VEHICLE RECALL

G- 05516-R1

G- 05517-R1

SUBJECT: SAFETY RECALL (U.S., EXPORT)

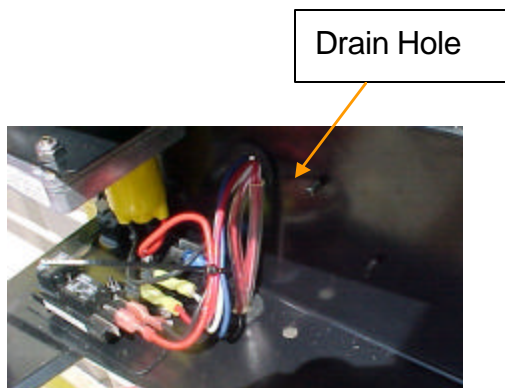
<p>15. Connect leads to new 005150 module as shown on schematic above. Leave two center tabs, +12VDC & GROUND, disconnected until module is fastened down in next steps. The yellow wire is no longer needed and can be tied back.</p>

16. Install new 005150 module into position as shown above. Timing mark **MUST** be facing toward the direction of the blade. (Ex. If blade is fully extended, timing mark must be turned to front of unit). Push module shaft through lower hinge hole. Fasten with (2) 11/32" hex nuts from original micro switch assy.
